SUNDRY NOTICES AND REPORTS ON WELLS
Do not use this form for proposals to drill or to re-enter an abandoned well. Use form 3160-3 (APD) for such proposals.

PLUG AND ABANDONMENT PROCEDURE

Jicarilla Apache Tribal 151 #1

Re: Permanent Abandonment
Well: 1 Jicarilla Apache Tribal 151

Proposed P&A

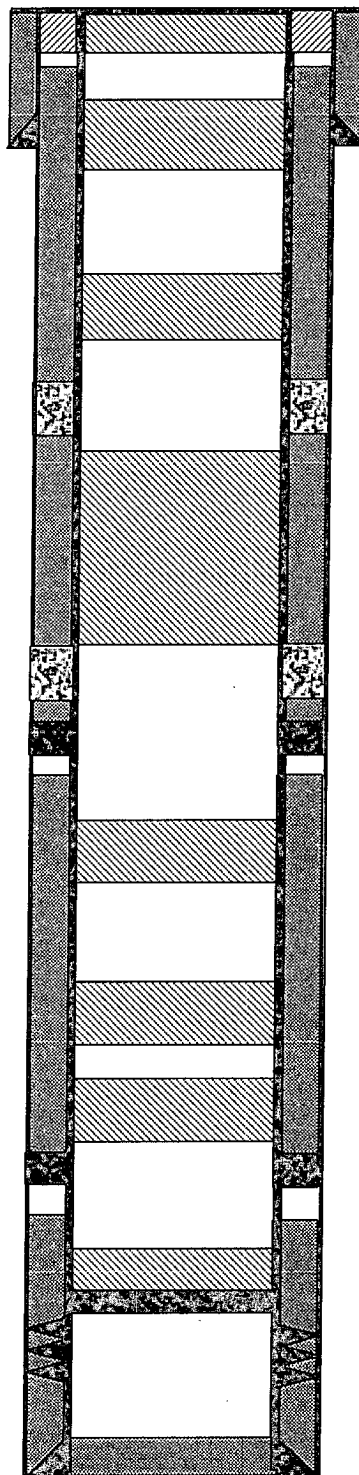
Nacimiento @ 1496' *est
1531

Ojo Alamo @ 2828' *est
74

Kirtland @ 3090' *est
3102

Fruitland @ 3465' *est
3300

Pictured Cliffs @ 3480'
3500

Chacra @ 4405' *est
18

Gallup @ 5878'
6674

Dakota @ 7700'
7699

1581 1481
Plug #6: 1646' - 1446'
Class B cement, 12 sxs

50 2824
Plug #5: 3530' - 2773'
Class B cement, 62 sxs

$$3550 - 2824 + 50 / 1.167 (1.18) = 59 \text{ sxs}$$

4468 4368
Plug #4: 4455' - 4355'
Class B cement, 12 sxs

6724 6624
Plug #2: 5920' - 5820'
Class B cement, 12 sxs

$$12 (1.167) 1.18 = 158'$$

1. Plugging operations authorized are subject to the attached "General Requirements for Permanent Abandonment of Wells on Federal and Indian Lease."
2. Farmington Office is to be notified at least 24 hours before the plugging operations commence (505) 599-8907.
3. The following modifications to your plugging program are to be made:
 - a) Place the Gallup plug from 6724' – 6624'.
 - b) Place the Chacra plug from 4468' – 4368'.
 - c) Place the Pictured Cliffs/Fruitland/Kirtland/Ojo Alamo plug from 3550 – 2824'.
 - d) Place the Nacimiento plug from 1581' – 1481'.

You are also required to place cement excesses per 4.2 and 4.4 of the attached General Requirements.
